**From:** Amanda Scholes on behalf of Planning.Responses  
**Sent:** 11 January 2022 08:55  
**To:** Planning Scanning  
**Subject:** FW: 95888 Land at Northwood Farm Flexible Generator Plant and associated infrastructure CM/69/21/PL  
**Attachments:** 20014-PP-006\_Fire Rescue Plan - (A0).pdf; IMG\_0299.JPG

Project Title:  
GENERATION COMPOUND  
LAND AT NORTHWOODS FARM  
YARFORD ROAD  
CLYMARING LITTLEHAMPTON

Drawing Title:  
PROPOSED SITE  
FIRE RESCUE PLAN

20014-PP-006

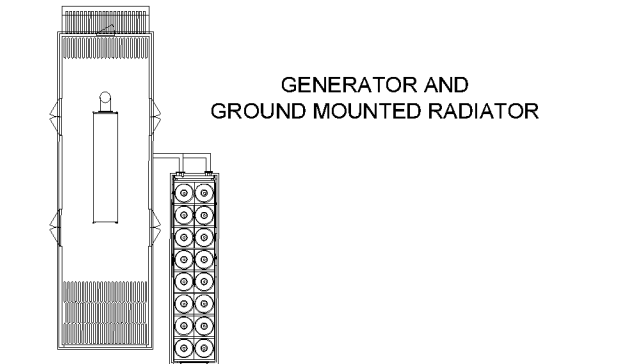
- **Fire Rescue Service** – we note that the FRS Water and Access department flag two issues, both of which we can suitably address (proximity to a fire hydrant connection and accessibility by a fire engine). Conrad's proposed site is one of the most accessible flexible generation sites that they are progressing through planning at the moment. The width of the access road adjoining the site is over 10m as it was a former aircraft runway back in its day. Having reviewed the document that Mr Stocks refers us to, the minimum road should be 3.7m wide (see page 122). Furthermore, the same access is used by HGVs accessing the adjacent waste and recycling plant a stones throwaway to our site. The technical engineers at Conrad Energy have allowed suitable room to allow a crane to safely turn/operate within the site during construction and therefore access for a fire truck should be achievable. There will also be a water connection provided onsite. For completeness and to counteract any further discussions on this matter, Conrad energy will provide you with a swept path analysis drawing which will be sent to you shortly.

We have proposed to position a Fire Hydrant within the red line boundary but outside of our compound which will be connected back via a new water pipe which will also provide fresh water to our welfare cabin in the southern corner.

We have highlighted the width of the road adjoining our site – 11.4m, which is over three times the “Minimum width of road between kerbs (m)” recommended in Table 15.2 within the ‘Approved Document B Volume 2, 2019 edition’. The full turning circle of a fire truck is 16.8m meaning a truck should be able to turn in three points here (If you think a SPA showing this turn would be useful then we can have this commissioned but hopefully from the basis of the above this should allay any concerns – please let me know). I have attached a photo which may help further the cause, showing the width.
